Request IR-1:

Reference to Page 1 of 6, NS Power notes: “Pursuant to Section 11.2 of the CEJC, related CIs for Steam projects include “work completed on the same asset (turbine, boiler, etc.) and on the same unit (Lingan Unit #3, for example)”:

(b) Please confirm whether above 2025 CIs are for separate work NOT included in the present application (CI C0067906).

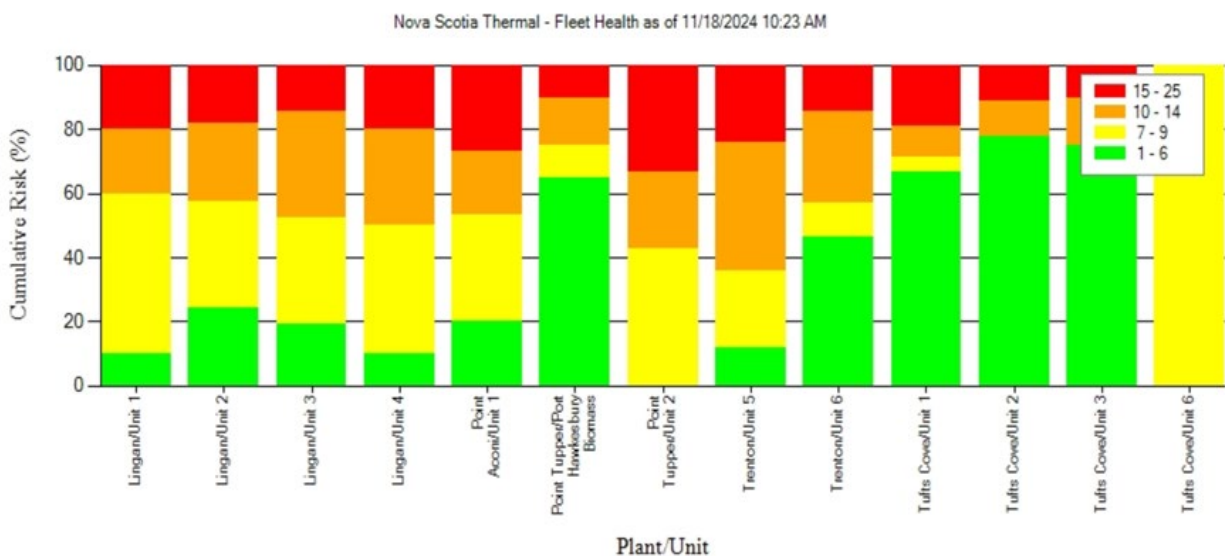
(a) Please provide the analysis report and supporting data related to this project.

(a) The refurbishment follows a standardized program-based approach with similar activities implemented annually. The final scope is determined each year following completion of inspections and is based on NS Power’s boiler condition data collection and analysis for that inspection cycle, which includes:

- Boiler Tube Failure Reports generated for any failure events that result in unit outages.
- Annual Boiler Inspection Reports conducted by NS Power's maintenance contractor under Boiler Asset Strategy Committee supervision.
- Header Inspection Program data, including ultrasonic thickness measurements and creep ranking calculations.
- Work Order history from NS Power's CMMS (DirectLine), used to identify recurring issues and validate maintenance effectiveness.
- Root Cause Analyses for past failures

This information is compiled and used to develop the boiler risk profiles for each site, represented below for each Unit.
